Denial Memorandum

Applicant: Mogul Group, LLC
Address: 34 Forrest Avenue, Rumson, New Jersey 07760
Block 42, Lot 1, Zone: R-5

I have reviewed the Zoning Board application for the construction of a new five-bedroom, single family dwelling and detached garage at the property listed above. The existing lot is a slightly undersized, narrow, corner lot which does not conform to primary lot frontage/lot width (Forrest Ave) or corner lot shape circle. For clarification, corner lots have one front yard, one rear yard (opposite the front), one regular side yard, and one side yard with a secondary front yard setback (Lakeside Ave). The new nonconformities are related to the secondary front yard setback.

PLOT/GRADING PLAN
 34 FORREST AVENUE
 LOT 1 BLOCK 42

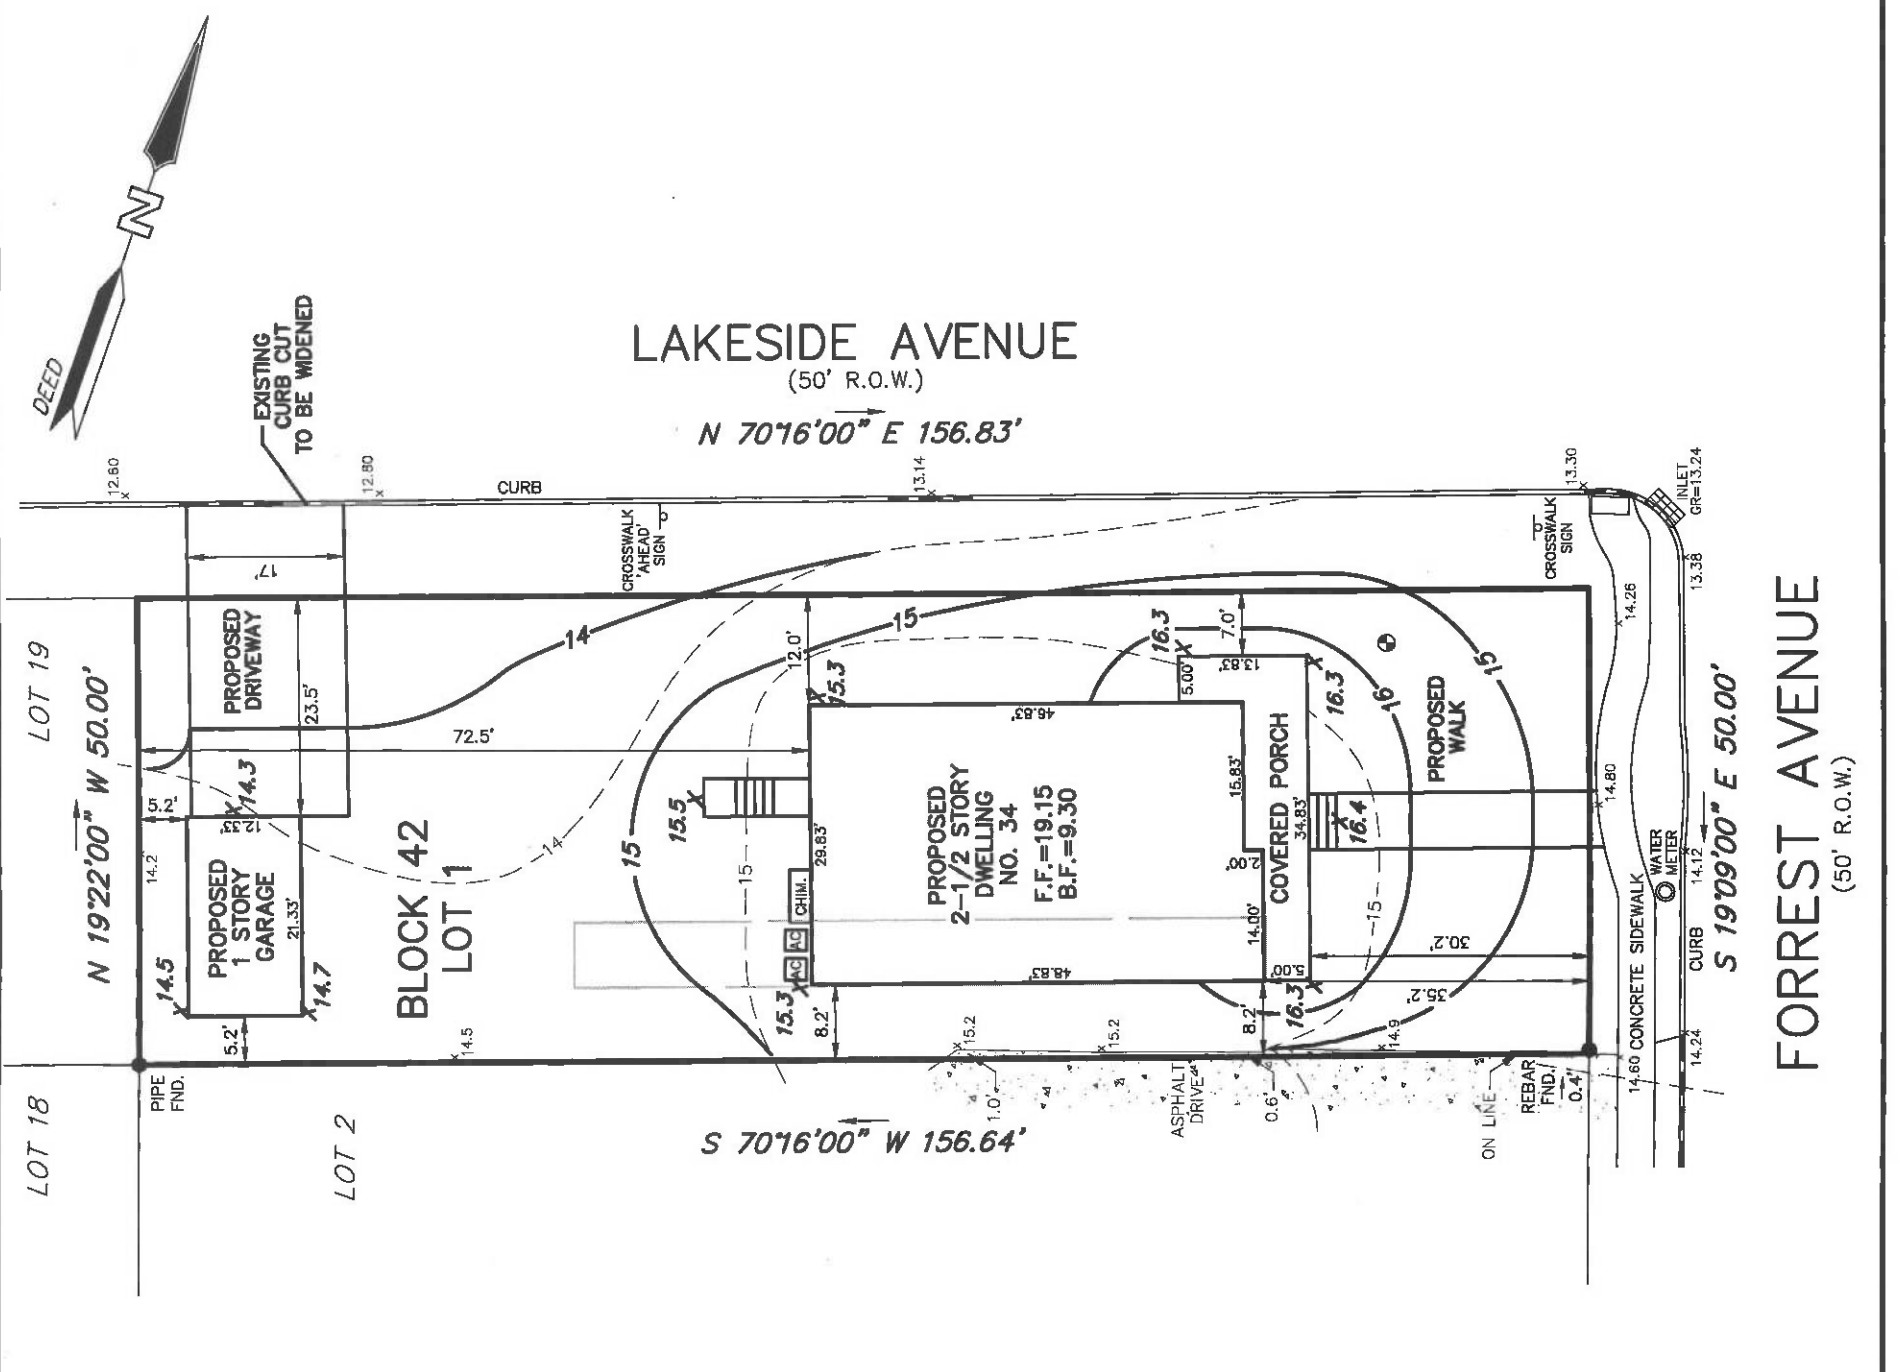
- Schedule 5-1 bulk variances
 - (Principal Bldg.) Secondary front yard setback of 12', whereas 35' is required (**New**).
 - (Principal Bldg. Porch) Secondary front yard setback of 7', whereas 35' is required (**New**).
 - (Accessory Bldg.: detached garage) Secondary front yard setback of 23.5', whereas 35' is required (**New**).
 - Minimum Lot Area of 7,836-sf, whereas 8,000-sf is required (**Existing, unchanged**)
 - Minimum Lot Frontage/Width of 50', whereas 75' is required (**Existing, unchanged**)
 - Minimum Corner Lot Shape Requirement of 7', whereas 33' is required (**Existing, unchanged**)
- (22-9.2b) Parking in the front yard setback (**New**).

- All new single-family houses applications are required to submit a landscape plan.
- There are a number of existing trees on this property. Please be prepared to discuss the protection and/or mitigation plan if applicable.
- Please provide a conforming location for a future generator installation.
